# Service Advisory

W-119

Subject: **POTENTIAL FUEL TANK LEAK**

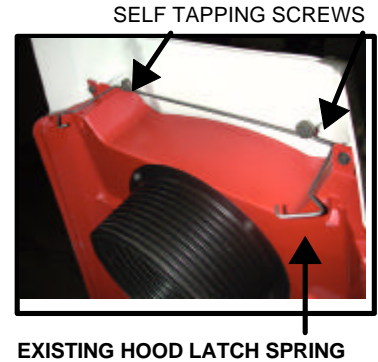
This is to inform you of a potential safety problem concerning the possibility that the hood latch spring may damage the plastic fuel tank of the White Outdoor Tractor models listed above. The ends of the hood latch spring may contact the sides of the fuel tank causing damage to the left and right side of the tank. There is a possibility that over time repeated rubbing of the hood latch on the sides of the tank could cause the tank to leak.

NEW HOOD LATCH SPRING  
(Has a curl on the end)

EXISTING HOOD LATCH SPRING  
(Has a straight blunt end)

- a) Loosen but do not remove the two self-tapping screws with a 3/8" wrench.
- b) Before removing the old hood latch spring, note the orientation of the latch where it wraps around on the two self-tapping screws which secure it to the hood (open end of bends around screws face forward). Once the proper orientation of the hood latch spring has been noted remove and discard the existing hood latch spring by sliding it from between the washers on the self-tapping screws.
- c) Position the new hood latch spring as noted during removal and install the new hood latch spring by sliding it between the two washers on the self-tapping screws.
- d) Tighten the self-tapping screws to secure the hood latch spring.

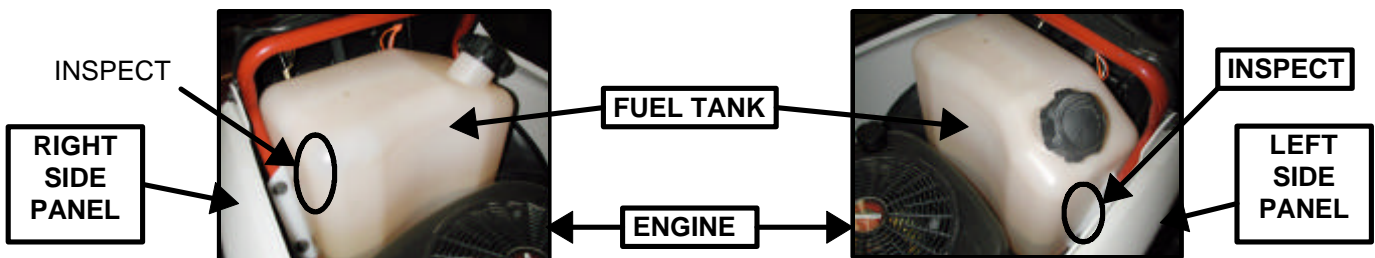
Visually inspect the left and right sides of the fuel tank at the areas shown in the photos below. These are the areas on the exterior side surface of the tank where the ends of the hood latch spring could rub when the hood is raised or lowered. **Look for any significant scratches or gouges in the sides of the plastic tank which could affect the integrity of the tank. If you find any significant scratches or damage, replace the tank.**

5. Replace the fuel tank as follows:
  - a) With the hood opened, disconnect headlight harness lead at plug.
  - b) Remove locknuts and washers from stud/bolts securing the side panels to the frame. If needed, use a wrench to prevent the stud/bolts from turning below the frame rail. Care must be taken to prevent the hood and side panel assembly from falling off the frame.
